# **Draft 100G SR4 TDP Update**

John Petrilla: Avago Technologies

January 2014

# 100G 100m SR4: Transition time & RIN<sub>12</sub>OMA tradeoff set TP3 contours (1)

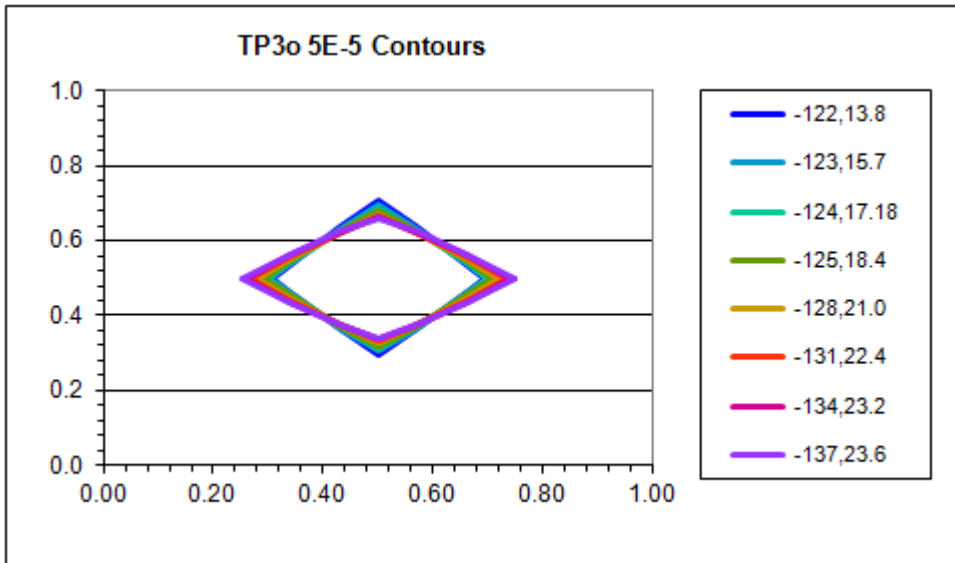
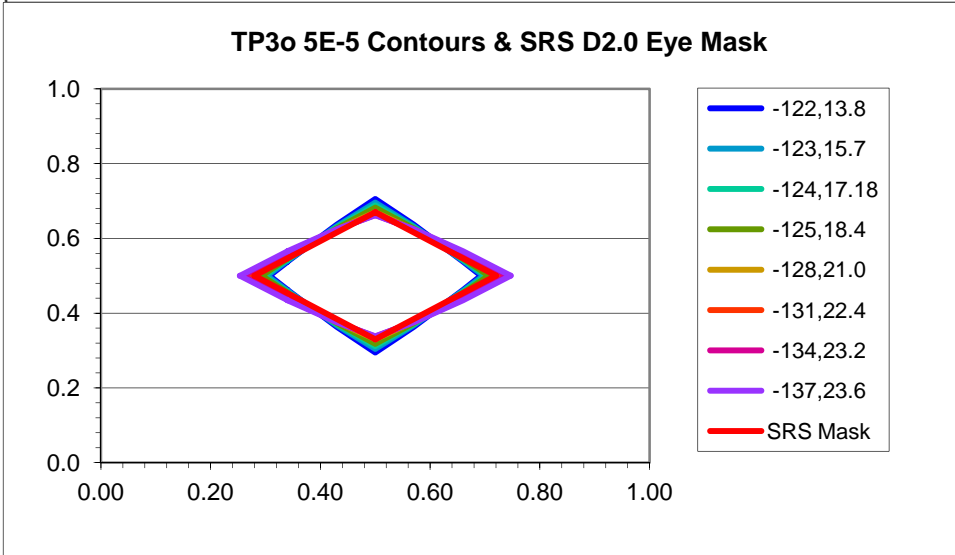
- The top chart shows 5E-5 contours of the fiber output (TP3) for the transition time and RIN<sub>12</sub>OMA combinations providing zero link margin used in an earlier page.
- The currently defined (draft 2.0) SRS eye mask is included for reference in the bottom chart. While it captures one of several worst case TP3 eyes, adjustment is appropriate to accommodate more of the worst case contour set.

# 100G 100m SR4: Transition time & RIN<sub>12</sub>OMA tradeoff set TP2 contours (2)

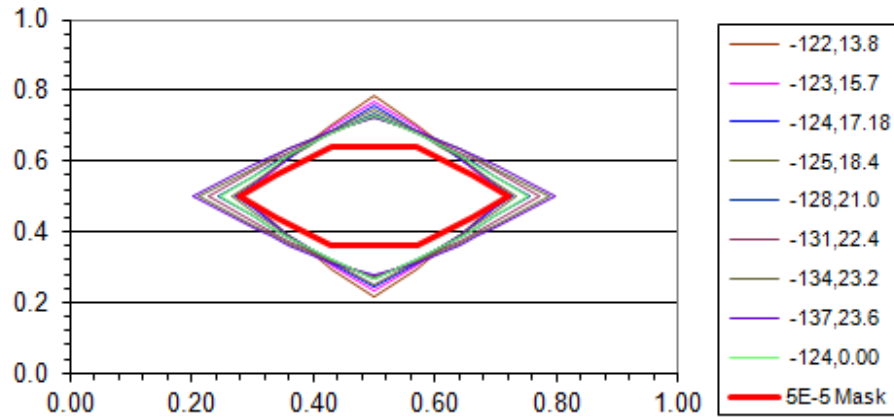
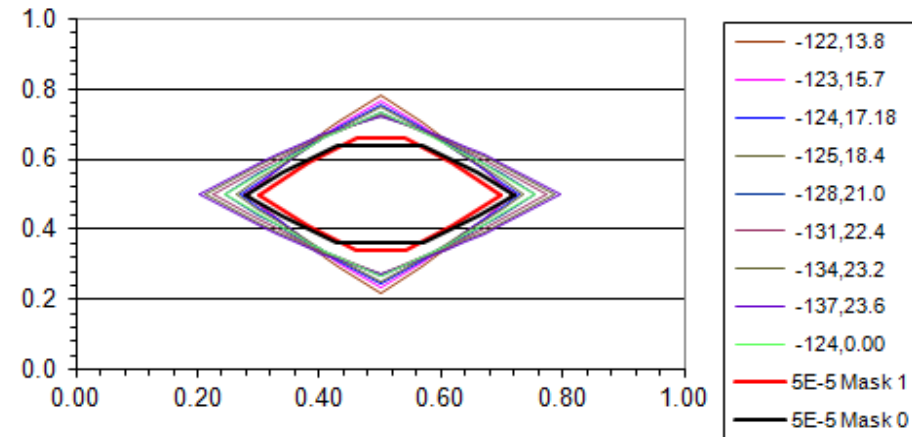
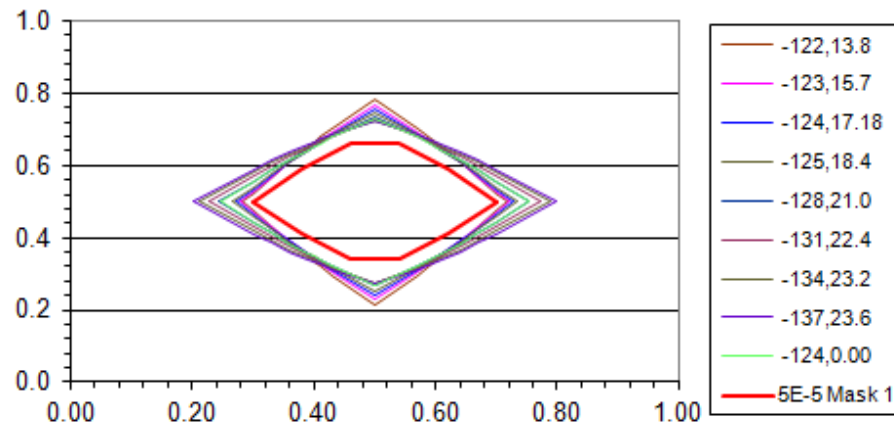
- All charts show a set of worst case Tx output 5E-5 contours.
- The currently defined (draft 2.0) Tx eye mask is shown in the top right chart with the set of 5E-5 contours.
- The proposed Tx eye mask (5E-5 Mask 1) is shown in the bottom left chart with the set of 5E-5 contours.
- The proposed Tx eye mask is compared with the existing Tx eye mask in the top right chart.
- Tx Eye Mask Coordinates: X1, X2, X3, Y1, Y2, Y3

Current: 0.28, 0.34, 0.43, 0.36, 0.44, 0.4

Proposed: 0.3, 0.38, 0.46, 0.34, 0.41, 0.4

# 100G 100m SR4: Transition time & RIN<sub>12</sub>OMA tradeoff set TP3 contours (2)

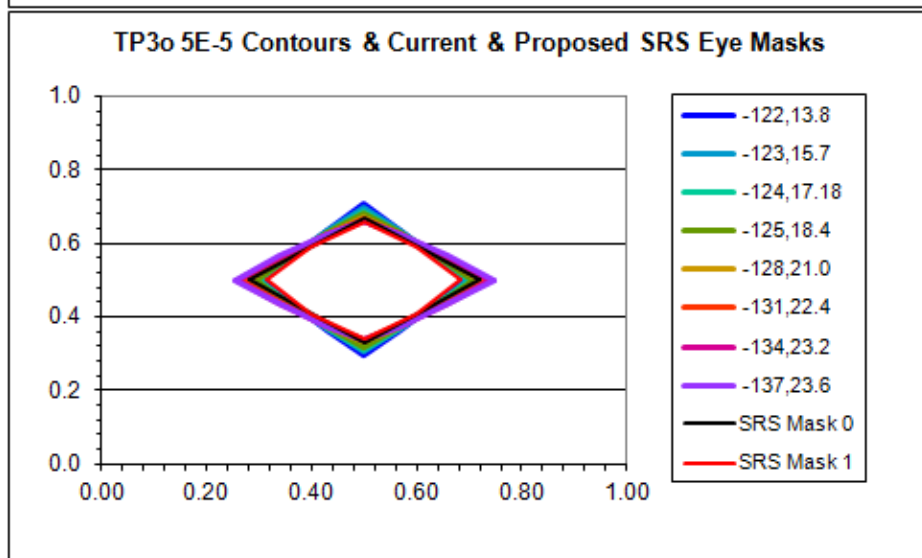
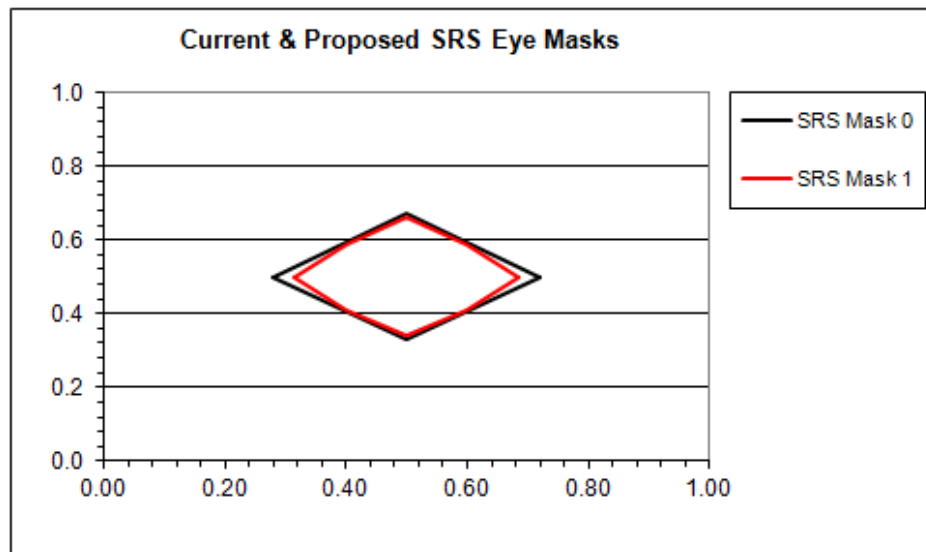
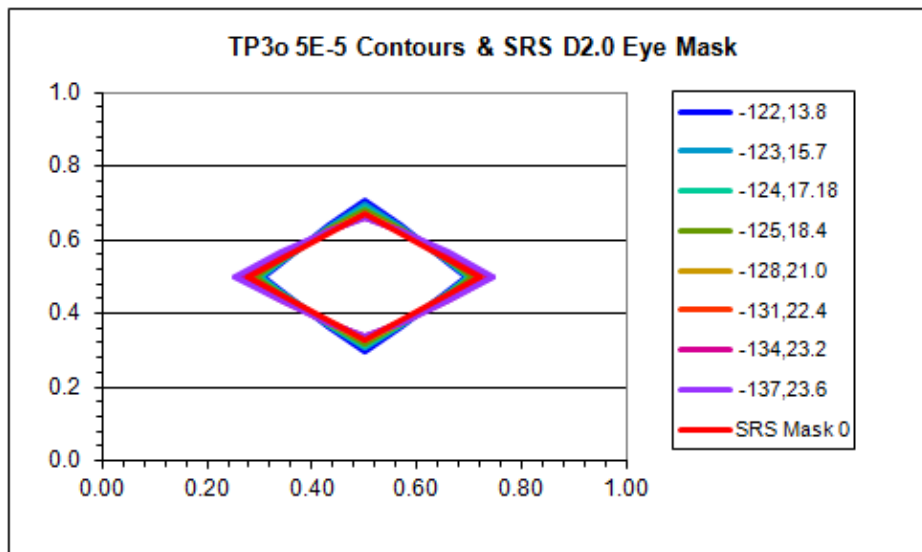
- The top left chart shows 5E-5 contours of the fiber output (TP3) for the transition time and RIN<sub>12</sub>OMA combinations providing zero link margin used in an earlier page and the current SRS mask (SRS Mask 0)
- The bottom left chart repeats the above and also shows the proposed SRS mask (SRS Mask 1).
- The top right chart provides a comparison of the current and proposed SRS masks.
- SRS Eye Mask Coordinates: X1, X2, X3, Y1, Y2, Y3

Current: 0.28, 0.5, 0.5, 0.33, 0.33, 0.4

Proposed: 0.315, 0.4, 0.5, 0.34, 0.41, 0.4

# 100G 100m SR4: A metric to replace TDP (1 of 4)

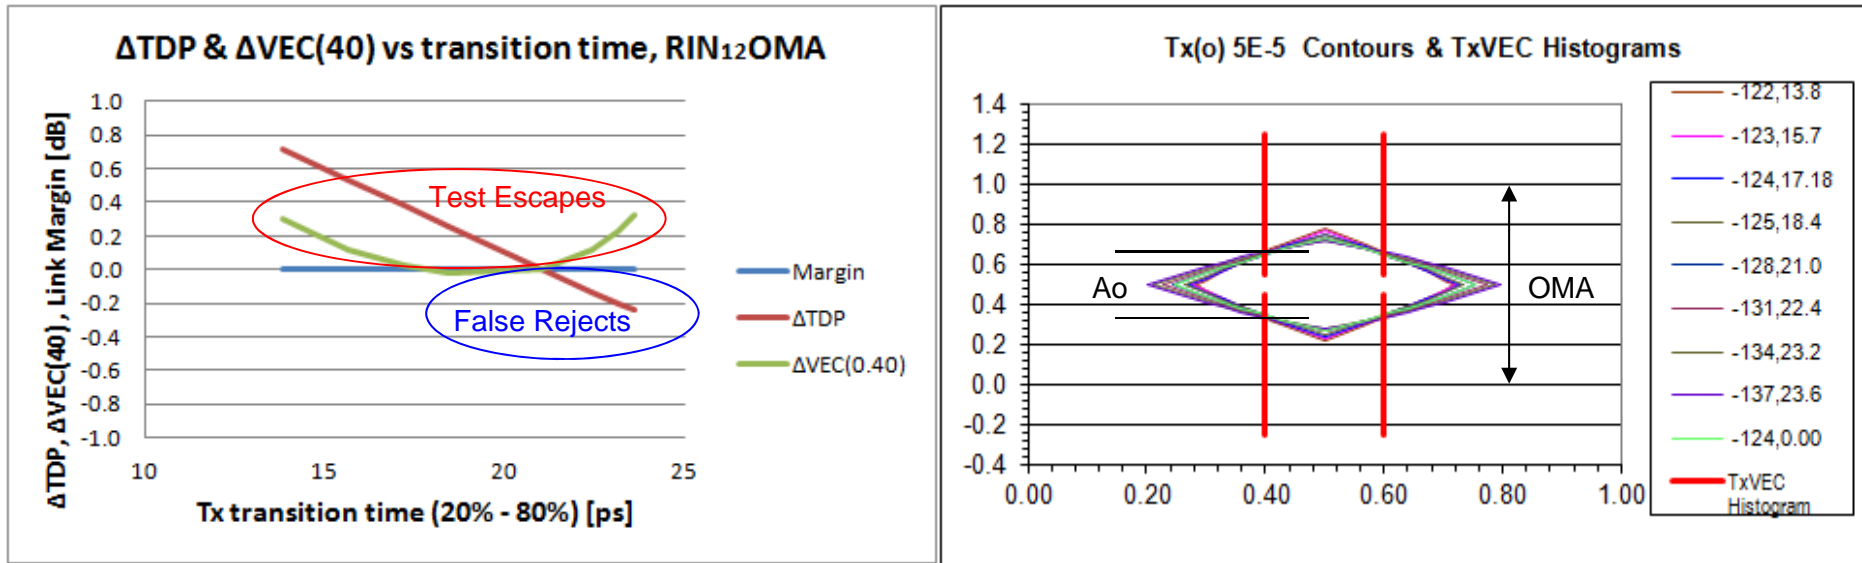
- The chart on the left indicates that a TxVEC metric, where  $TxVEC = 10\log_{10}(OMA/Ao)$ , can offer a better balance of test-escapes versus false-rejects than a TDP metric . Here histograms are taken at  $\pm 0.10$  UI. Ao is the vertical eye height between 5E-5 points on the histogram tails. OMA is the signal amplitude measured with the OMA measurement method.

- The  $\DeltaVEC(0.40)$  line is based on deviation from TxVEC calculated for the Tx baseline condition of a 21 ps Tx transition time and a RIN<sub>12</sub>OMA of -128 dB/Hz. For this baseline condition TxVEC = 5.12 dB and based on this condition a **TxVEC max = 5.1 dB is recommended.**

- Note that there is no need for a reference transmitter for the TxVEC measurement. With the inability of TDP to predict link margin shown above, the use of a non-ideal Ref Tx to calibrate the Sensitivity of the Ref Rx is suspect.

# 100G 100m SR4: A metric to replace TDP (2 of 4)

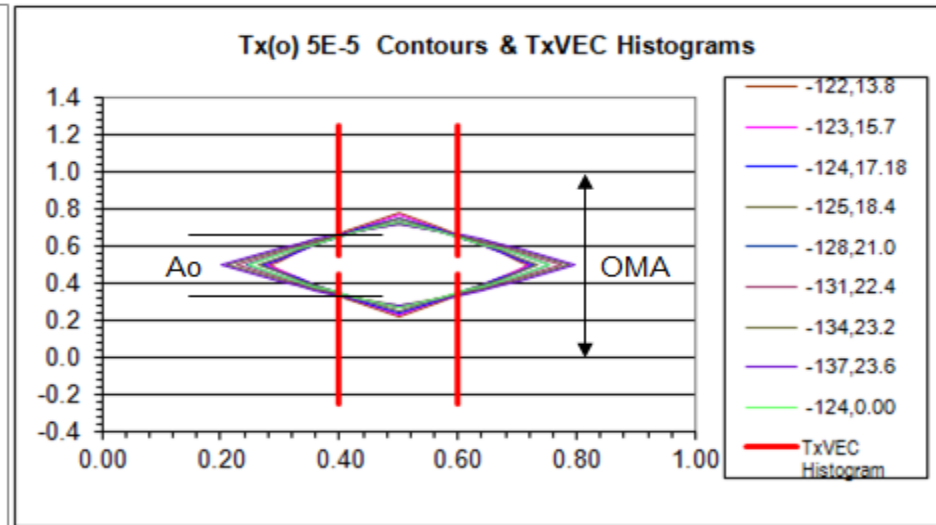
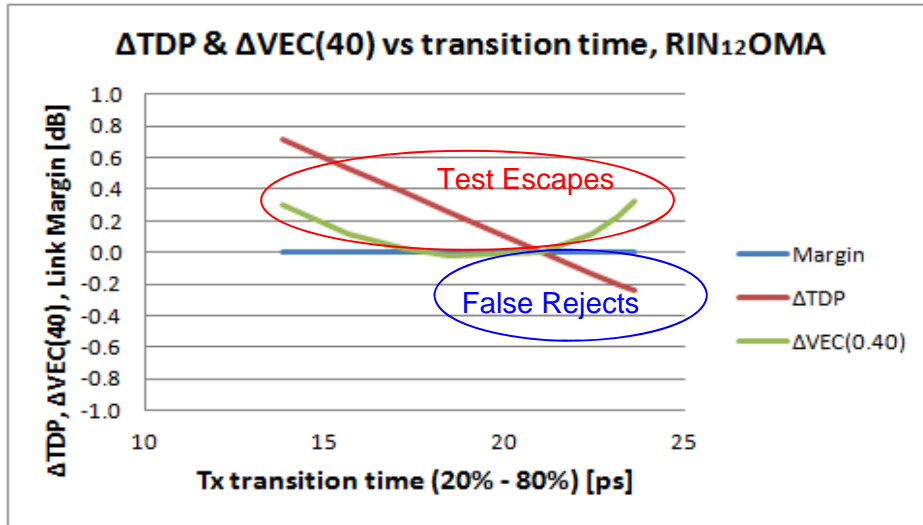
- Based on the new metric TxVEC, in Draft 2.0 replace
  - in Table 95-6, Transmitter and dispersion penalty (TDP), each lane (max) = 5 dB  
with Transmitter vertical eye closure, each lane (max) = 5.1 dB
  - in Table 95-6, Launch power in OMA minus TDP (min) = -8 dBm  
with Launch power in OMA minus TxVEC (min) = -8.1 dBm
  - in Table 95-6, Optical Modulation Amplitude (OMA), each lane (min)<sup>b</sup> = -7.1 dBm  
with Optical Modulation Amplitude (OMA), each lane (min)<sup>b</sup> = -7.2 dBm
  - in Table 95-6, footnote b, Even if the TDP < 0.9 dB, the OMA (min) must exceed this value.  
with Even if the TxVEC < 0.9 dB, the OMA (min) must exceed this value.
  - in Table 95-8, Power budget (for max TDP) = 8.2 dB  
with Power budget (for max TxVEC) = 8.2 dB
  - in Table 95-8, Allocation for penalties (for max TDP) = 6.3 dB  
with Allocation for penalties (for max TxVEC) = 6.3 dB
